**Subject: Recall Number 04V-130
2002-2004 Model Year Bentley Arnage R, RL, T, and LIMOUSINE
Bentley Recall Number RE04/02**

RE: RECALL CAMPAIGN - FUEL PIPE QUICK CONNECTORS - FEED AND RETURN - SAFETY CLIP FITMENT - REM0402

Bulletin 04-01-31-01

FUEL PIPE QUICK CONNECTORS – FEED AND RETURN - SAFETY CLIP FITMENT

Fig 1

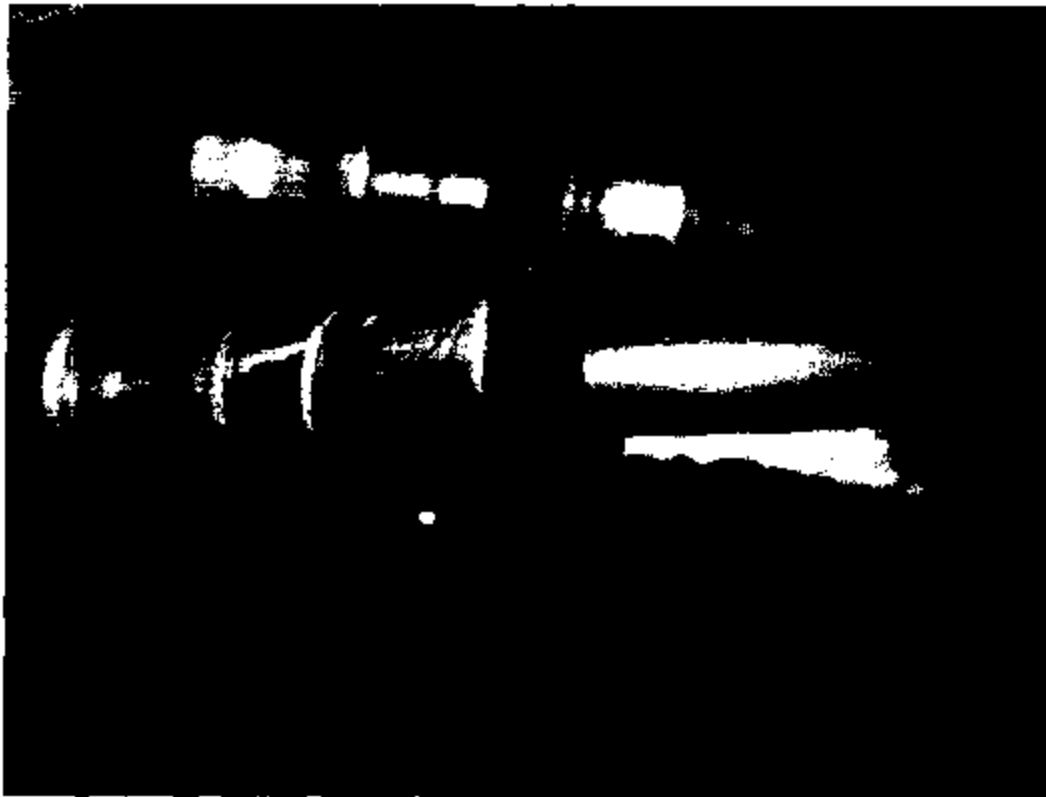
6. Push back the release collar and simultaneously pull the hose from the pipe fitting. Refer to figure 1.

Fig 2

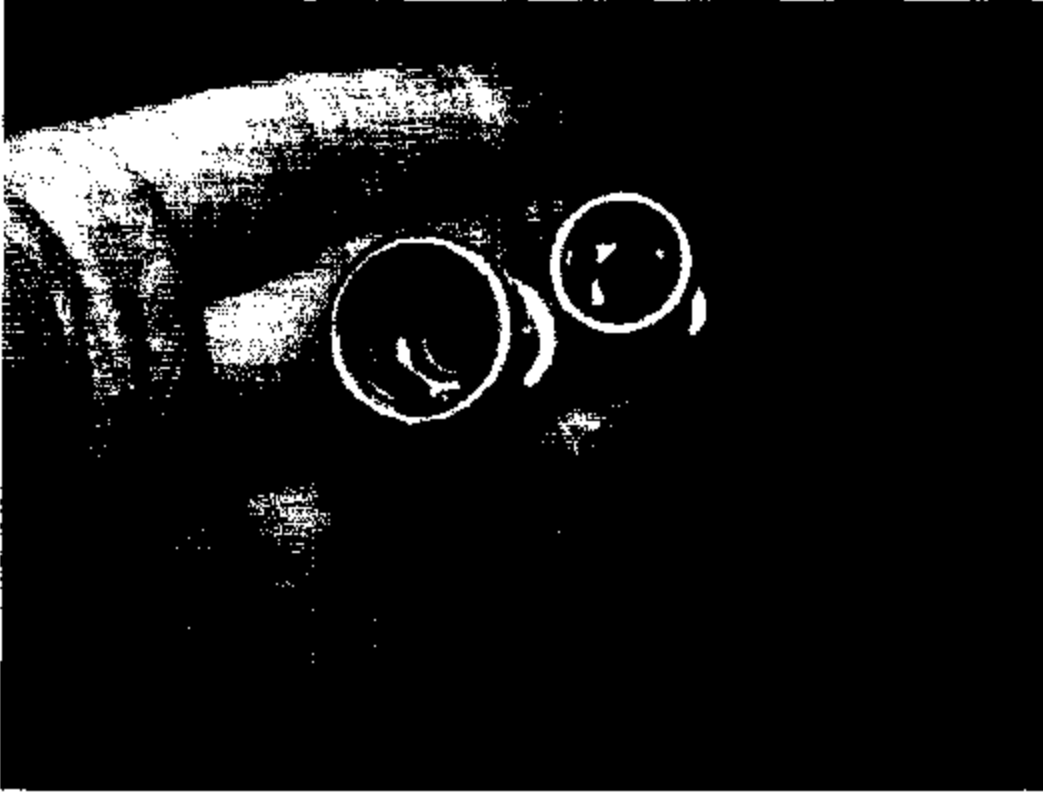
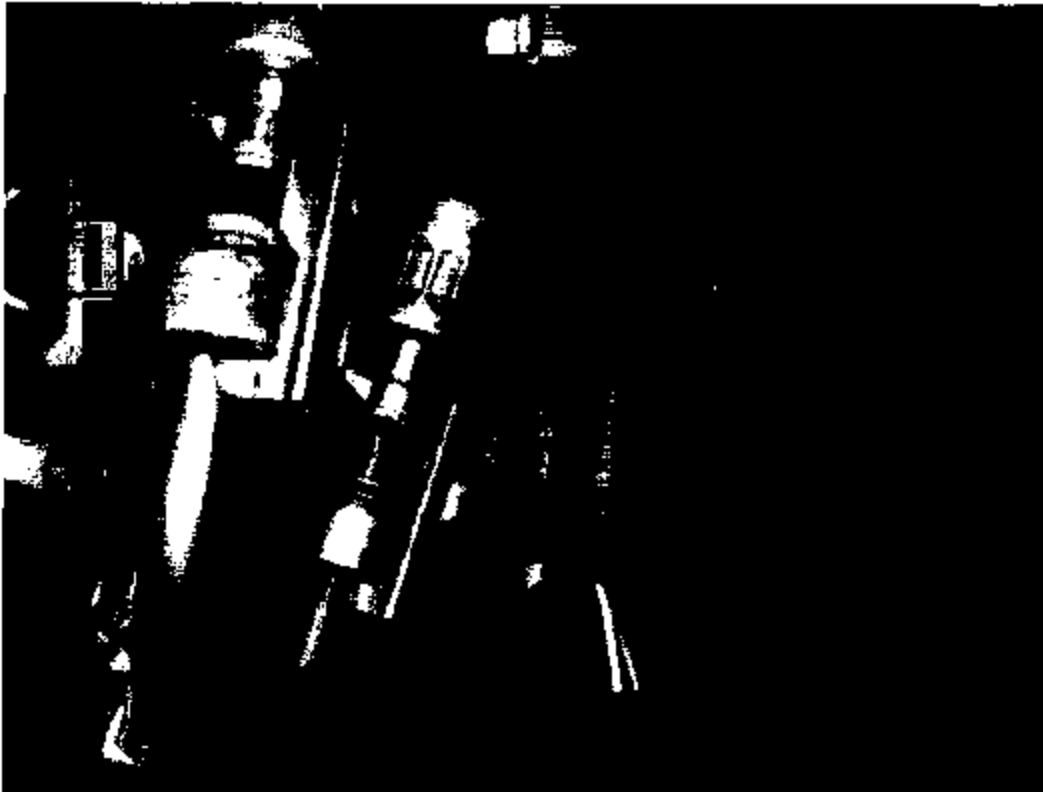
7. Remove and discard the release collar, using suitable pliers, from both quick connectors Refer to figure 2 & 3.

After the removal process, ensure no remaining parts of the collar are in the quick connector.

Fig 4

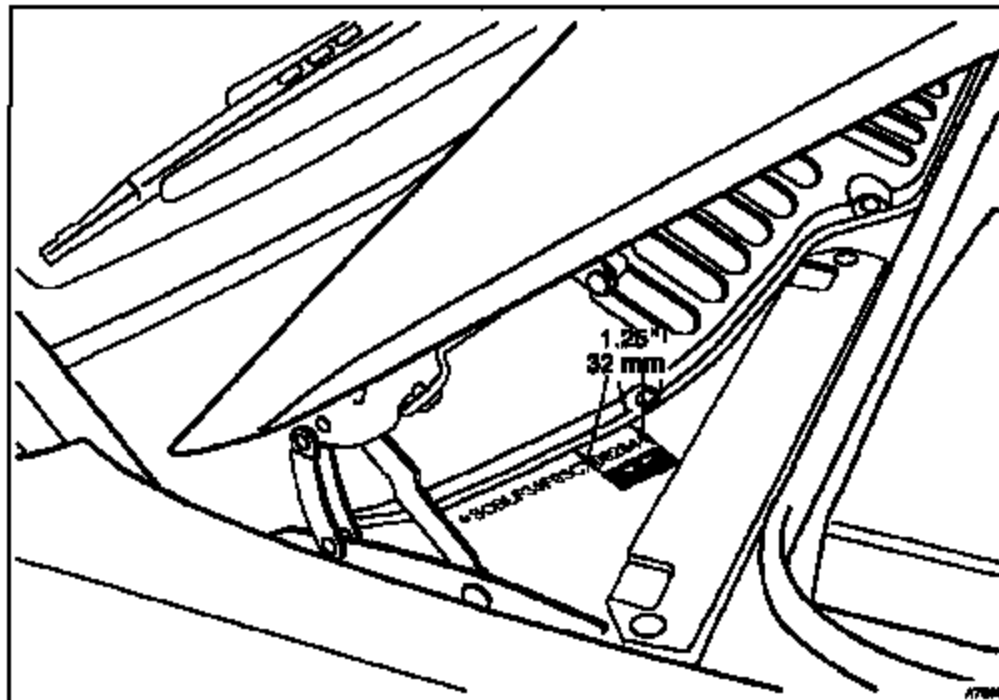
13. Fit a secondary retaining safety clip part number PF113200PA to the quick connector Refer to figure 4.
14. When the procedure has been carried out on both the fuel feed and fuel return quick connectors reconnect both batteries ASSIST PIN 5903.
15. Observing the relevant workshop safety procedures Refer to ASSIST PIN 00 39. Turn on the ignition and allow at least 5 seconds for the fuel system to pressurise then check the quick connectors for leaks.
16. Start engine and once again check pipe connections for leaks and if necessary rectify.
17. Refit right hand torsion strut ASSIST PIN 6012.
18. Fit label part number PS113432PA In position shown. Refer to figure 5.
19. Take bonnet out of service position refer to ASSIST PIN 8103.
20. Refit engine cover refer to ASSIST PIN 0950.
